FORD 4R100 "UPDATE HANDBOOK"

FORD 4R100 "UPDATE HANDBOOK"

Since the introduction of the 4R100 transmission in model year 1998, there have been many engineering changes to improve Pleaseability, Reliability and Durability concerns. These changes have affected most every part used in this transmission. This "Update Handbook" will explain each change, the reason for the change, and any parts interchangeability concerns created by the change, along with any part numbers needed to update your transmission.

Figure 52

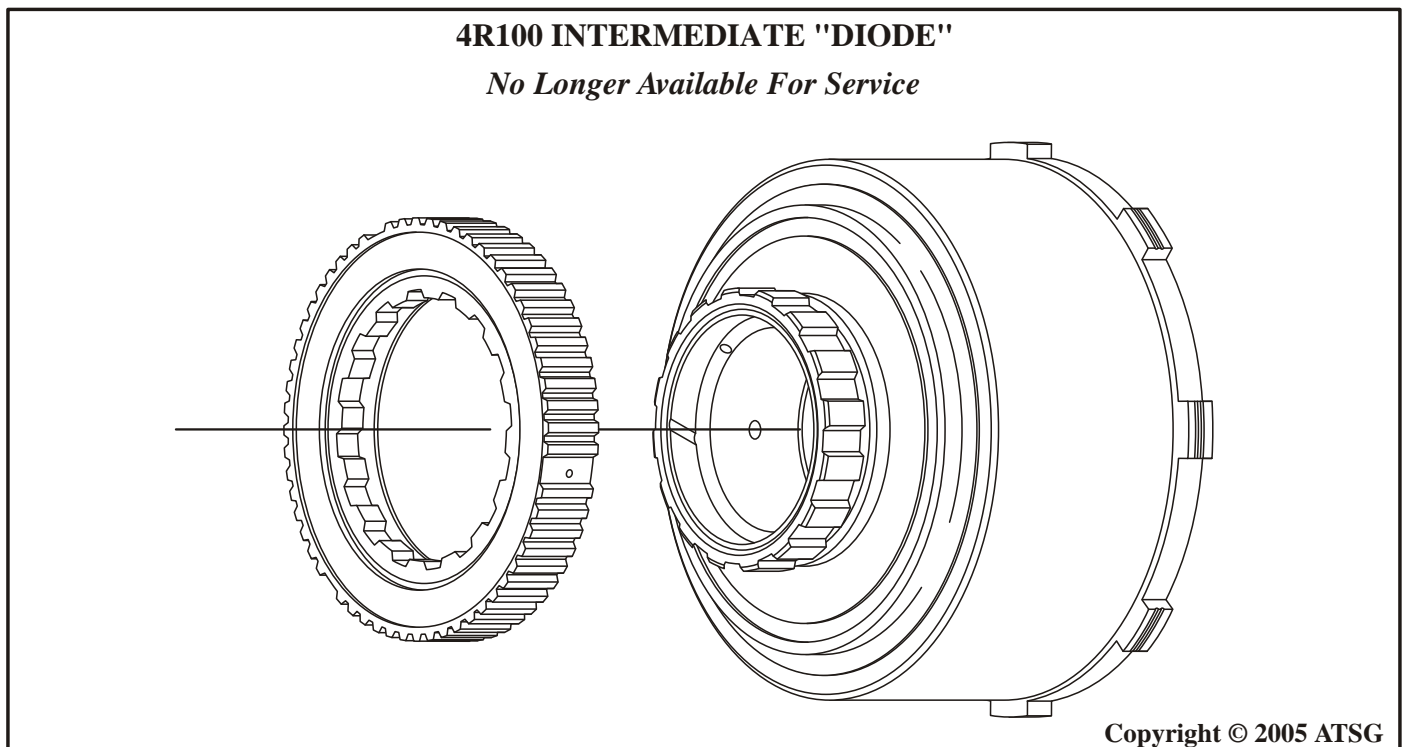
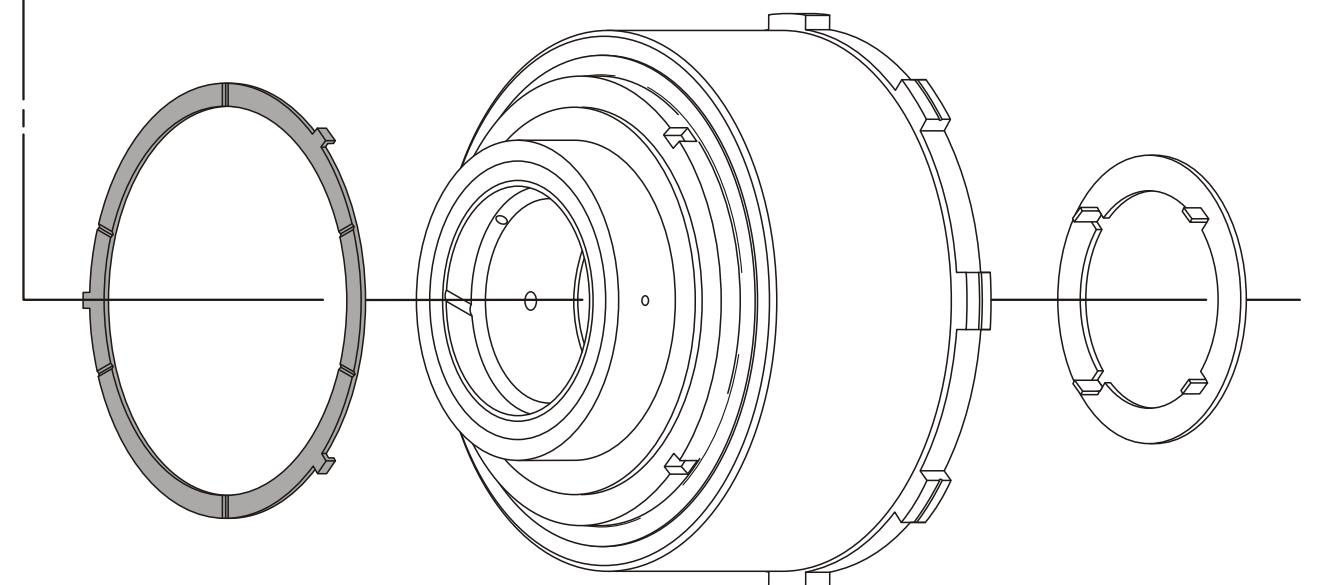
COMPLAINT: Some Ford Motor Company vehicles equipped with the 4R100 transmission may exhibit premature failure of the newly introduced Intermediate "Diode" Freewheel device that was installed in model year 2001 and illustrated in Figure 52.

CORRECTION: The Intermediate "Diode" is *no longer serviced* by Ford Motor Company. The part number now supercedes to all of the previous design level parts, which include the direct clutch housing, intermediate sprag assembly, outer race to direct drum thrust washer, and the intermediate friction plates. All of the previous design level parts are illustrated in Figure 53, with the OEM part numbers. The intermediate frictions must be replaced because the tooth count on the outer race between the diode and the sprag are different.

Figure 53

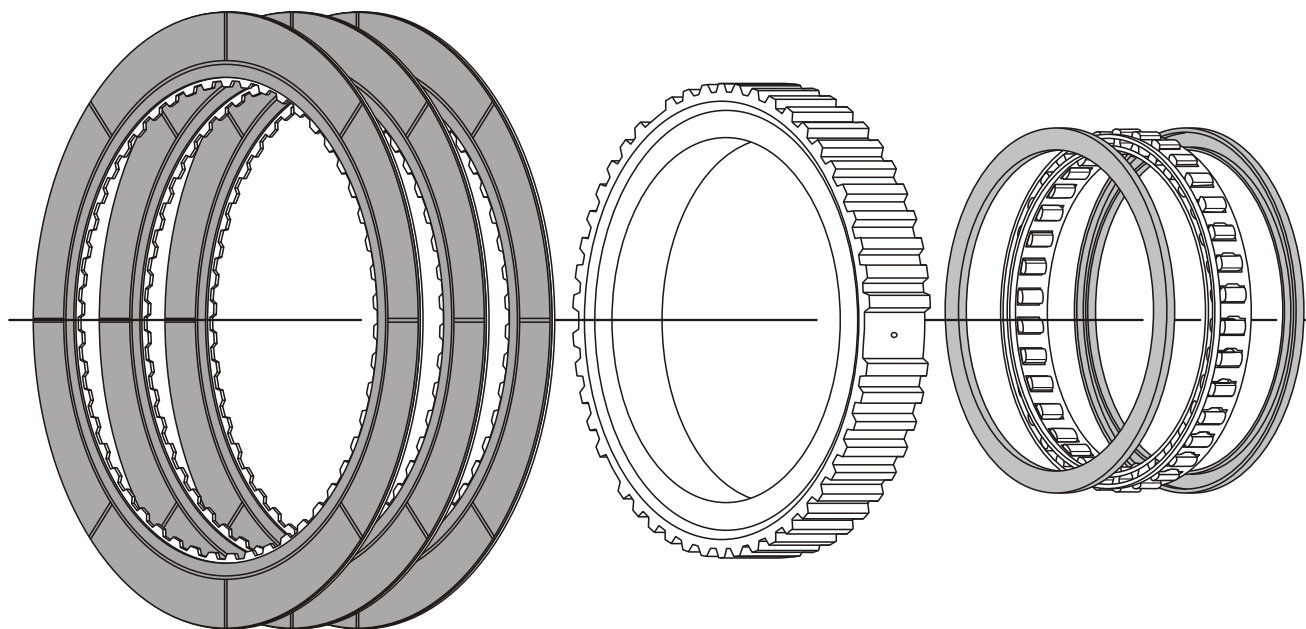
PARTS NEEDED TO REPLACE INTERMEDIATE DIODE

Intermediate Friction Plates
Part Number 1C3Z-7B164-BA
(Or Raybestos Plates OK)
(3 Required)

Intermediate Sprag Assembly
Part Number E9TZ-7A089-B

Outer Race To Drum Thrust Washer
Part Number E9TZ-7G401-A

Figure 65

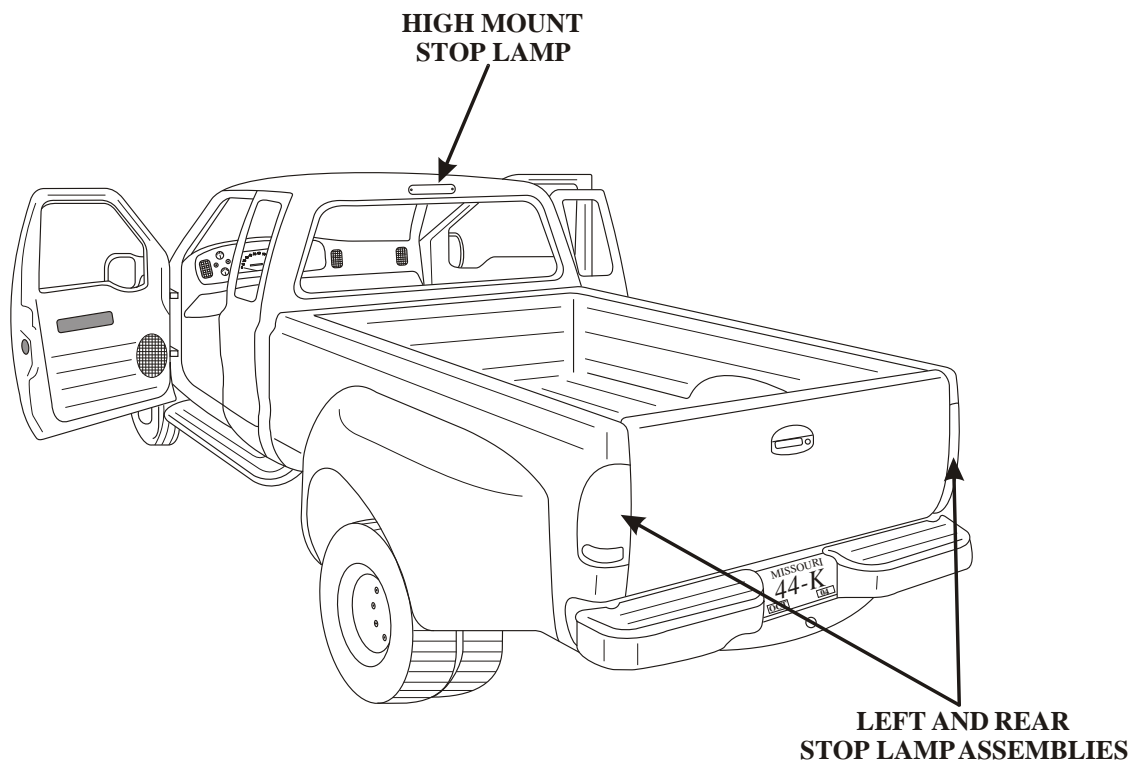
CAUSE NO. 1: One cause for this condition may be that one or more of the vehicle brake light bulbs, including the High Mount brake light may be burned out, or have a damaged filament (See Figure 65). When this condition is present, the PCM will detect an open in the brake lamp circuit, and due to a pull-up resistor in the PCM, will output voltage from PCM terminal 92 to the brake on-off switch (See Figure 66). As a result, the Torque Converter Clutch will not be applied at less than 30 percent throttle.

Prior to any part replacement or modifications, it would be recommended to check for a 5 to 8 volt DC signal coming out of the PCM at terminal 92 using a volt meter set to read DC voltage. Voltage may also be checked at the Light Green wire located at the back of the Brake On-Off Switch. **Note:** *The example given is for a 1996 F-Series 7.3 Diesel.* This test will help to confirm that a circuit fault has been detected by the PCM. Refer to Figure 66. **Normal operation will be 0 volts DC, brake off, and 12 volts DC, brake on.**

Replace any burned out brake lamp bulbs, including the High Mount brake lamp bulb, as shown in Figure 65. It is also important to note, that a bad ground for the rear lamp assembly, has also been known to cause the identical symptom. Refer to Figure 69 for the rear lamp assemblies ground location.

Figure 70

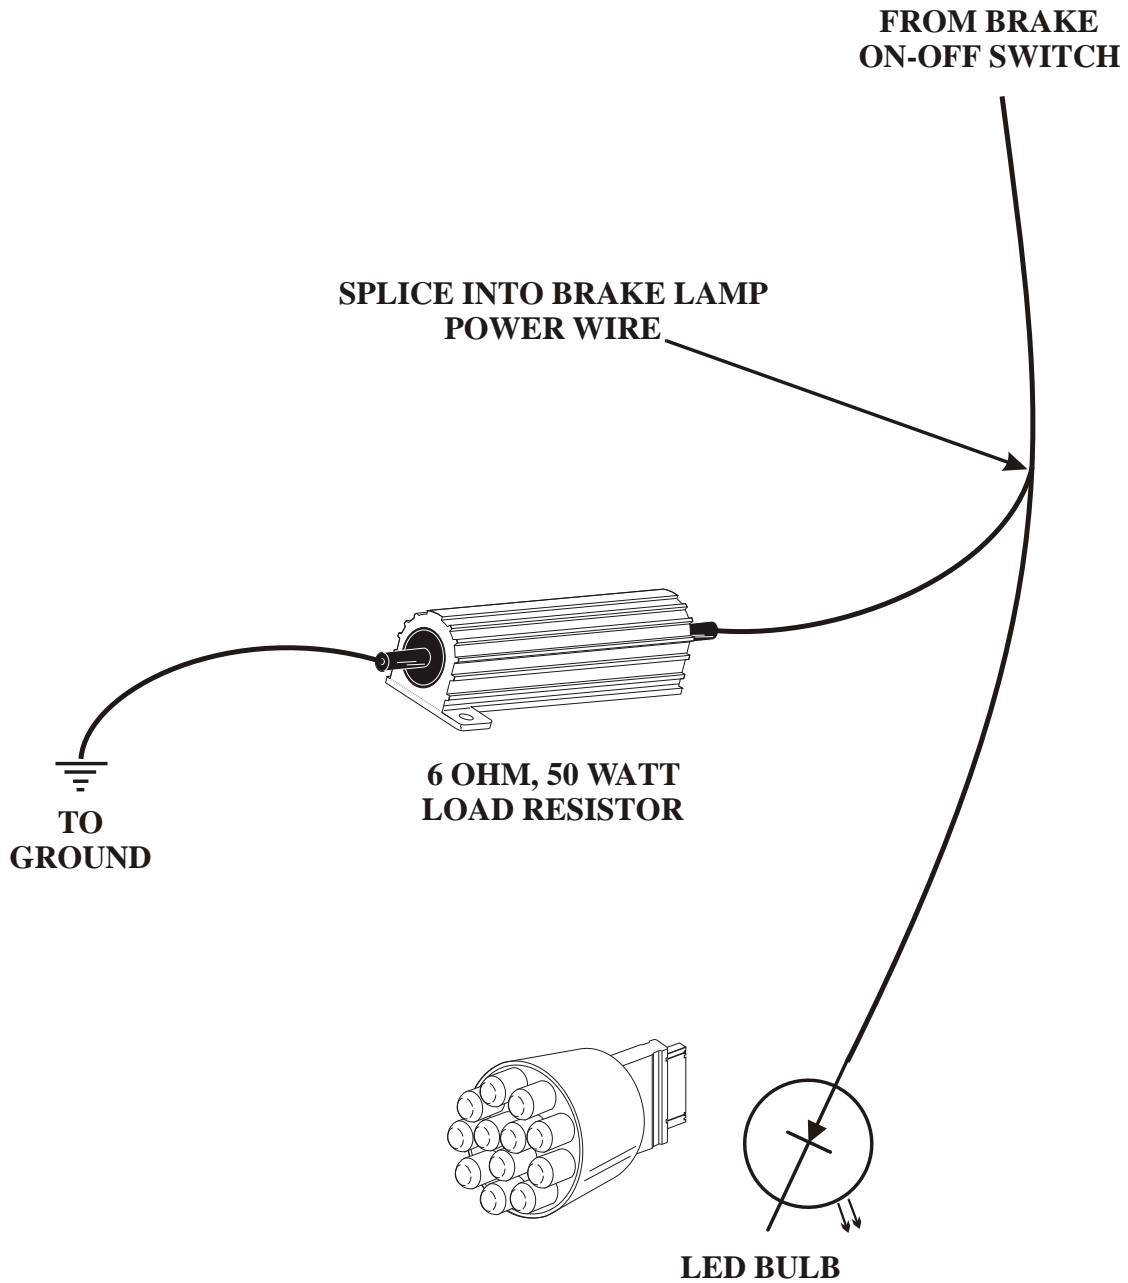
For those vehicles that have had the stock incandescent bulbs replaced with aftermarket LED bulb assemblies, it *may* be necessary to install a 6 ohm- 50 watt Load Resistor across the brake light power wire to simulate the load of the regular stock incandescent bulb (See Figure 70). **Note:** *One resistor is required for use on each LED bulb assembly.*

Figure 71

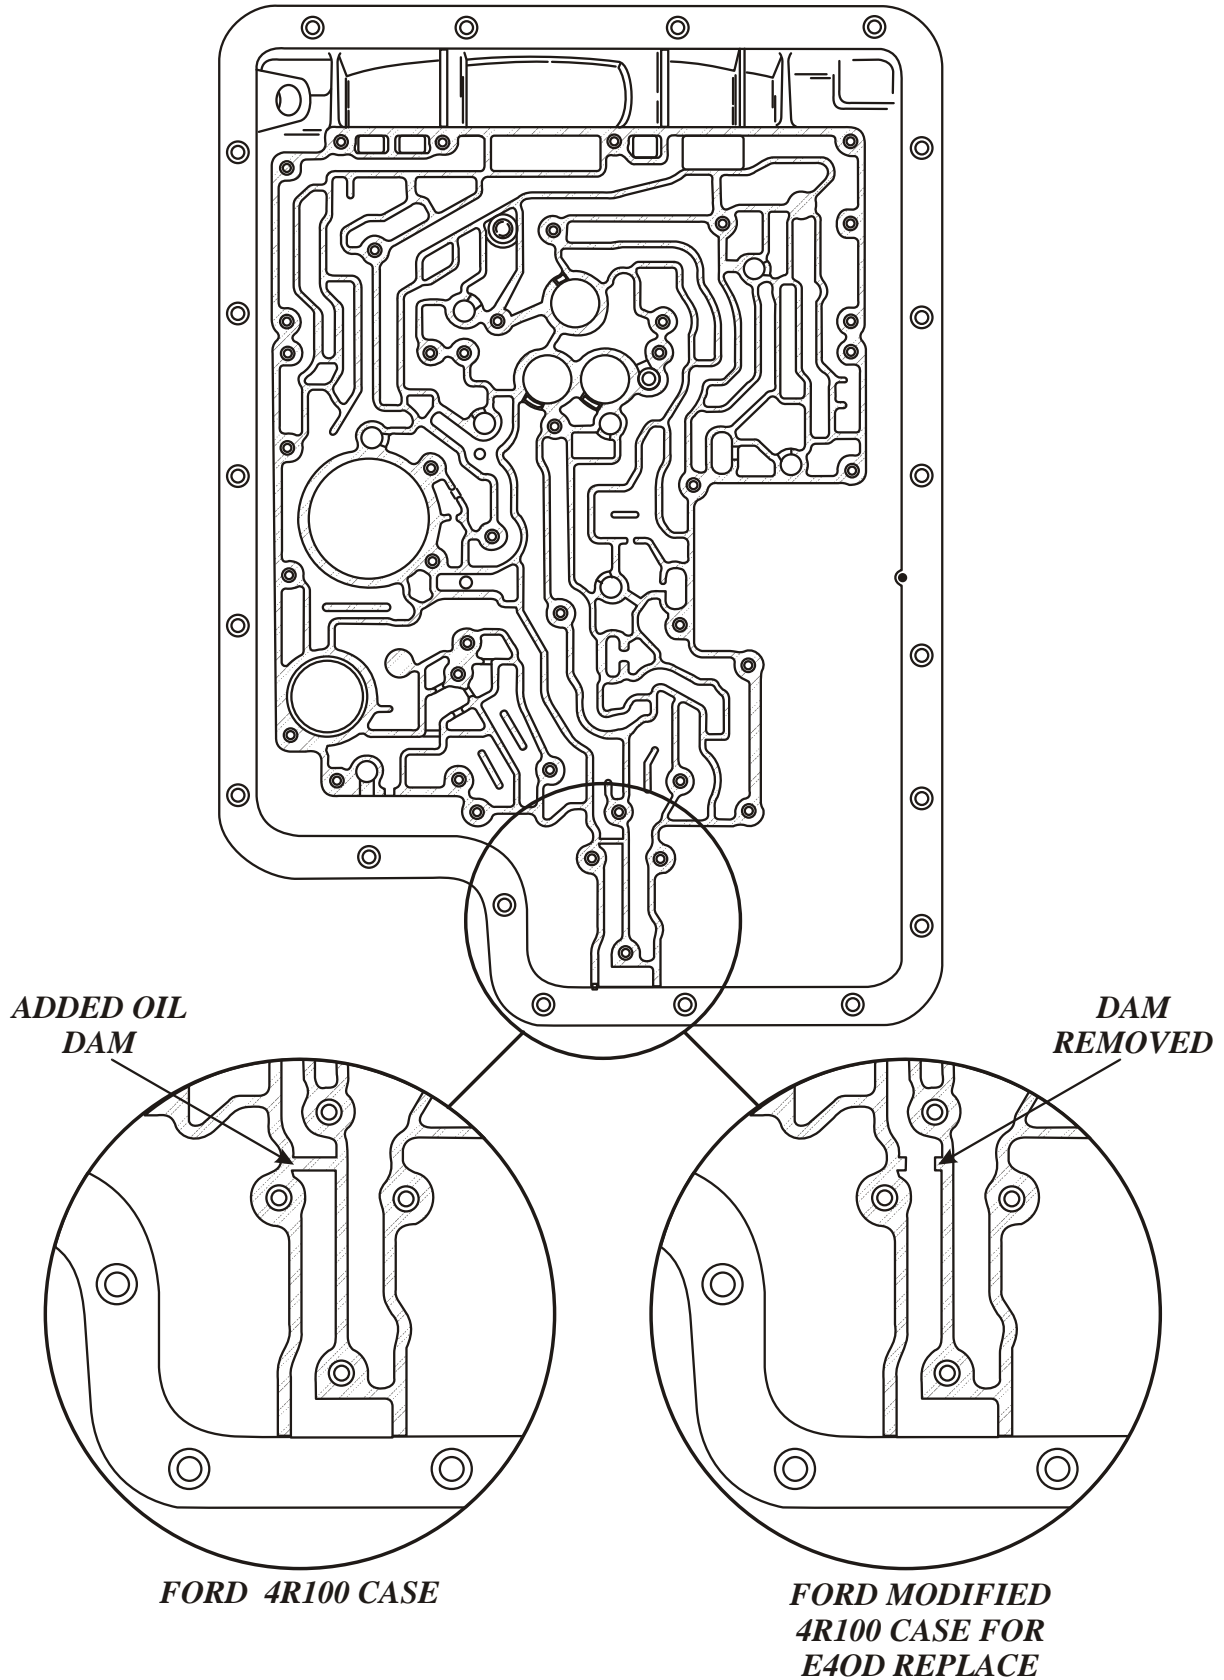
CHANGE: Currently, the "*only*" new case available from Ford Motor Company, for replacement in any E4OD equipped vehicles, is a modified 4R100 case. Ford has machined out the dam in the case that separates center and rear lube, near the rear of the case, as shown in Figure 71.

Figure 72

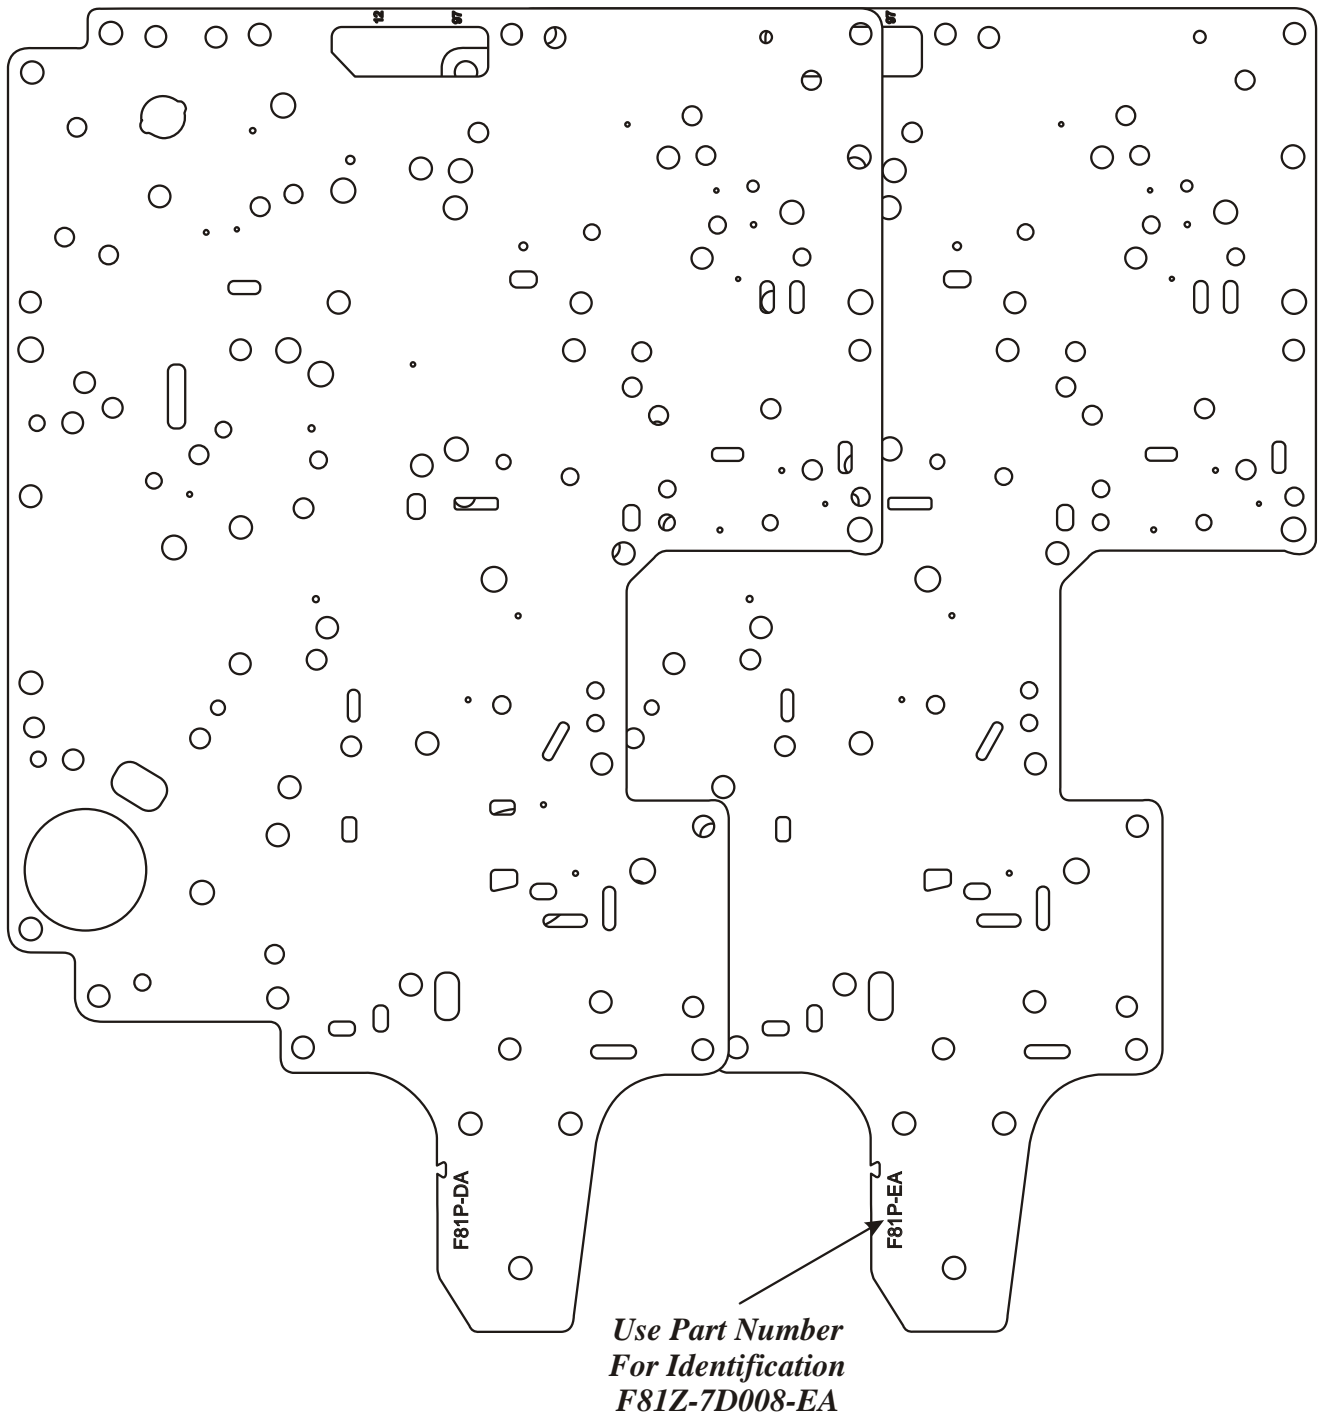
- (1) SPACER PLATE - Ford Motor Co. part number F81Z-7A008-EA or F8UZ-7A008-CA, as shown in Figure 72.
- (2) CASE TO SPACER PLATE GASKET - Ford Motor Co. part number F81Z-7C155-AA, with "White" stripe for identification, as shown in Figure 73.
